Subject: RE: 47 Golding Road and 50 Pukekohe East Road Model Review

Subject: 47 Golding Road and 50 Pukekohe East Road Model Review

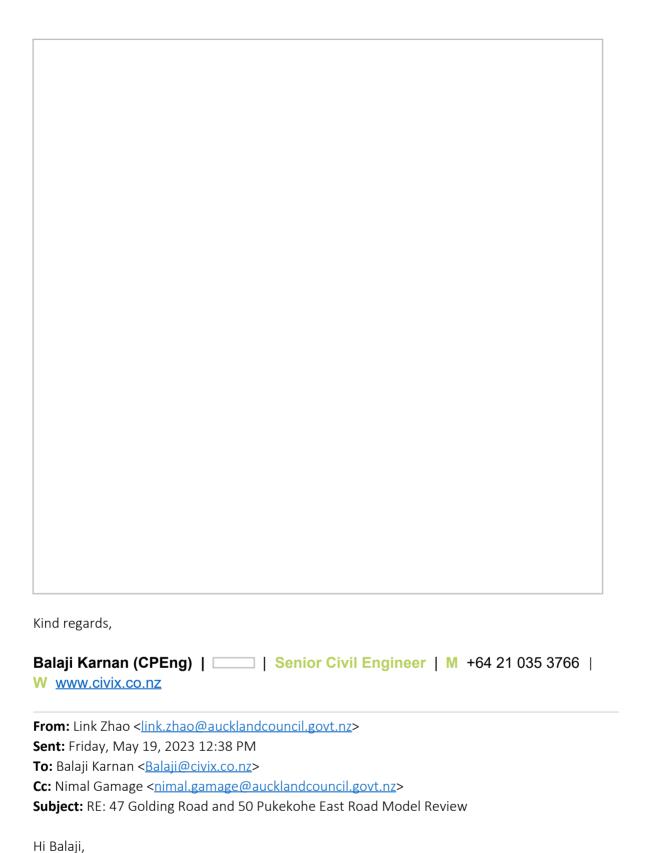
Are you able to provide a snip of exact section where the water level time series is provided. Is it as shown in the red line below:

Please see the water level time series (downstream side of Valley Road) of 100yrsCC and 10yrsCC attached. The data was extracted from AC 2022 regionwide rural rapid flood model, which was also done by Tuflow.

In order to model it accurately, it may be necessary to make some adjustments to ensure that the peak flow of the model aligns with the boundary level provided.

Additionally, I would like to emphasize the importance of considering the 1800mm culvert located under Valley Road.
